**ALTERATION TO A HISTORIC PROPERTY STAFF REPORT**

Site: 198 Central Street c.1880 Cutler Downer Mansard Rowhouse  
Case: HPC 2015.015 198-200 Central Street Local Historic District

Date of Application: April 1, 2015  
Legal Notice: *Alter rear doors, windows, and porch for egress.*  
Staff Recommendation: Certificate of Appropriateness  
Date of Public Hearing: May 19, 2015

*Rear of building from Adams Street  
mansard dormer and corner of second  
floor deck visible from Adams Street.*

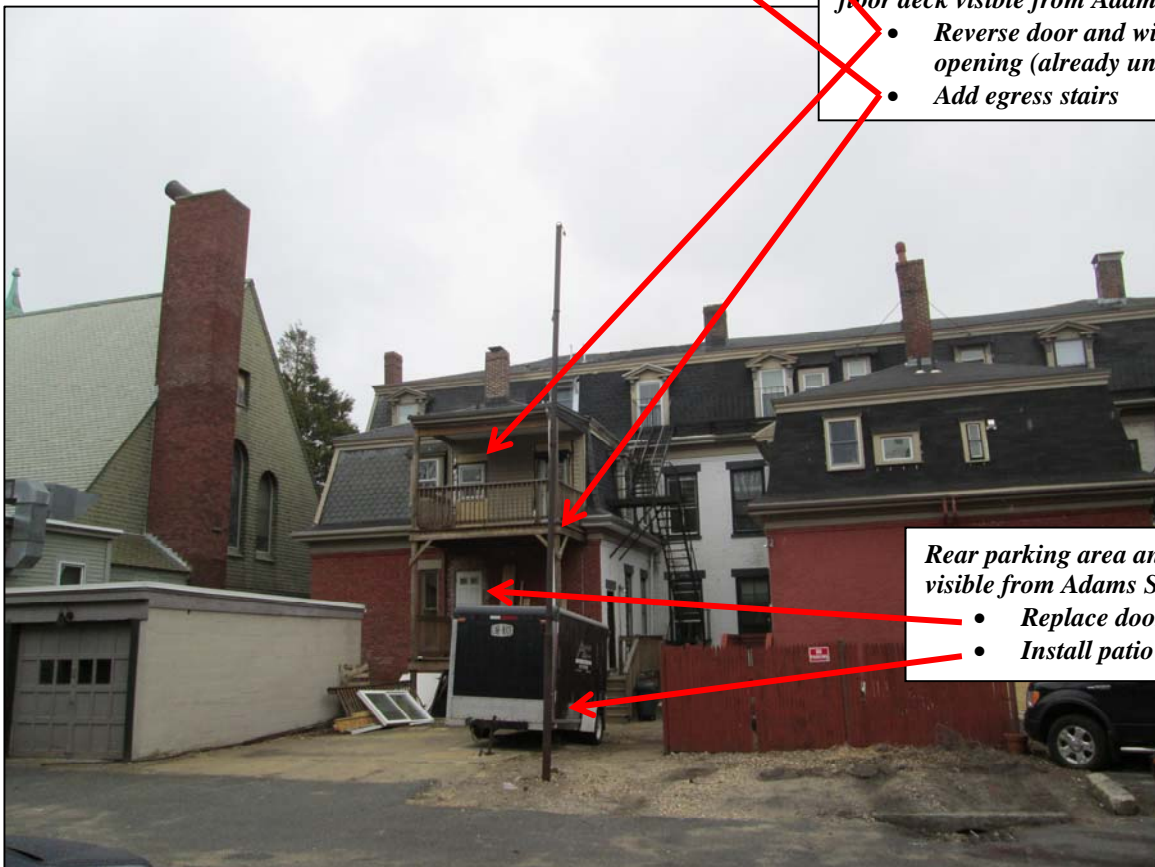
- Reverse door and window opening (already underway).
- Add egress stairs

- Replace door with window
- Install patio and HVAC.
